Challenges with dSNDR Measurement

Ali Ghiasi - Ghiasi Quantum

IEEE 802.3dj Interim Meeting
New Orleans

May 12, 2025

Figure 179–4—Calculation method for transmitter Δ SNDR

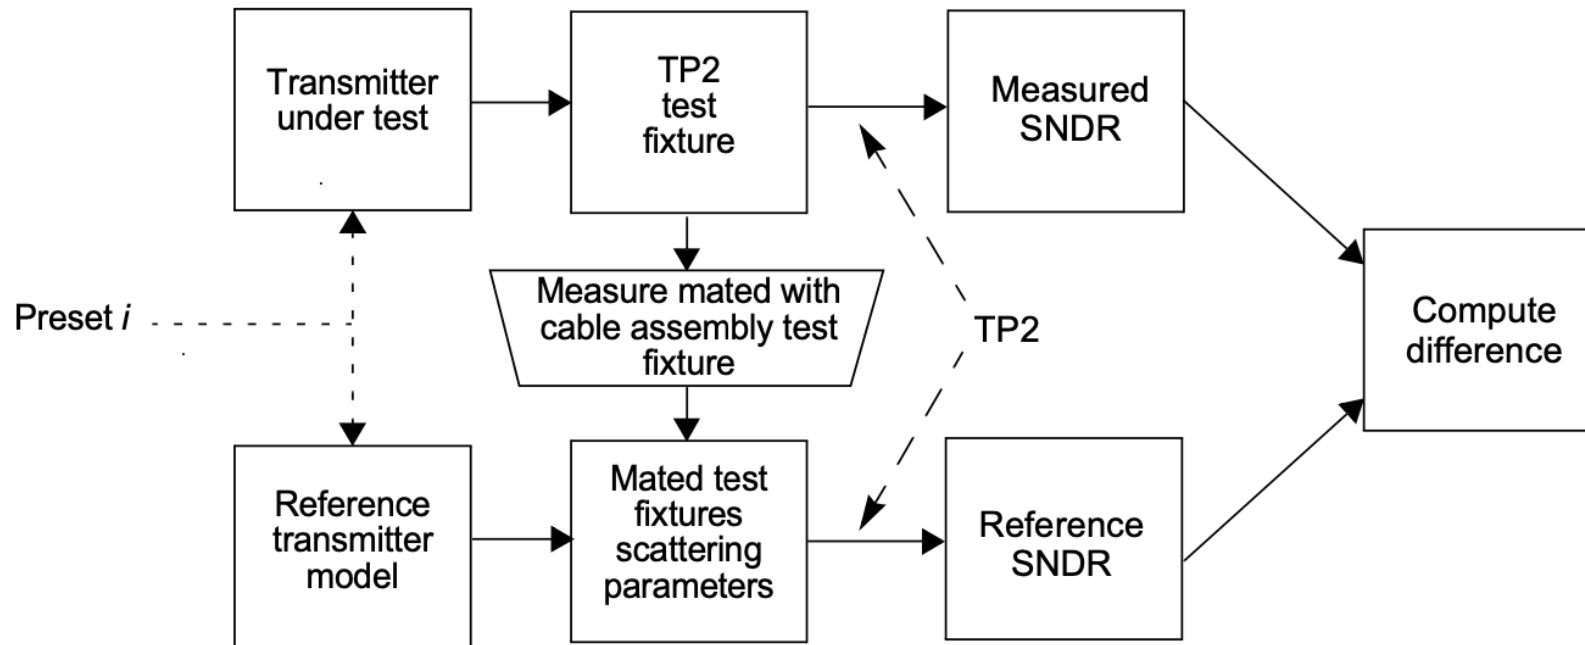
- ❑ **dSNDR as defined require S-Parameter measurement for the DUT channel for test points TP1a and TP2 which is impractical for 512 lanes and tedious**
 - dSNDR may improve SNDR accuracy in ideal world but establishing baseline SNDR overly burdensome and therefore impractical
- ❑ **Ethernet specifications must be observable and measurable at the port (TP1a or TP2) without requiring to open the box, remove the package, and use a probe station to measure S-Parameters for 512 lanes switch**
- ❑ **Task Force need to find an alternate measurement method to dSNDR as current method is impractical**
 - Only if synthetic channel with given IL can be used instead of measured channel then dSNDR is an acceptable method otherwise need to find an alternate test method to dSNDR.

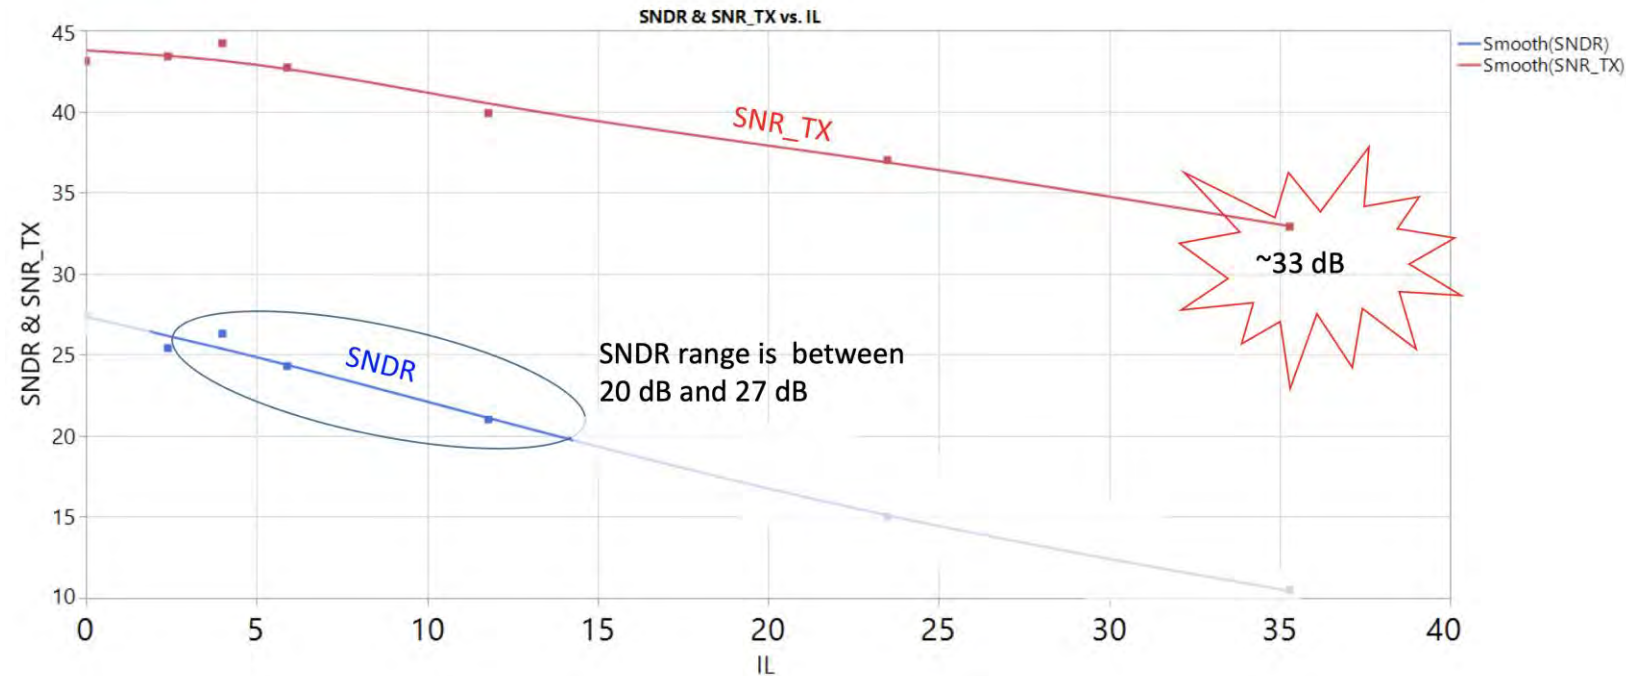
- dSNDR is calculated for Clause 178 KR defines dSNDR at TP0v
 - Measuring S-Parameters on a test board and performing calculation for two packages and two traces is not overly burdensome
- dSNDR is calculated for Clause 178 KR defines dSNDR at TP2
 - Require measurement of all host channel (512) then cascaded with two packages and two traces is just impractical
- dSNDR is calculated for Clause 176C defines dSNDR at TP0v
 - Measuring S-Parameters on a test board and performing calculation for two packages and two traces is not overly burdensome
- dSNDR is calculated for Clause 176D defines dSNDR at TP1a
 - Require measurement of all host channel (512) then cascaded with two packages and two traces is just impractical.
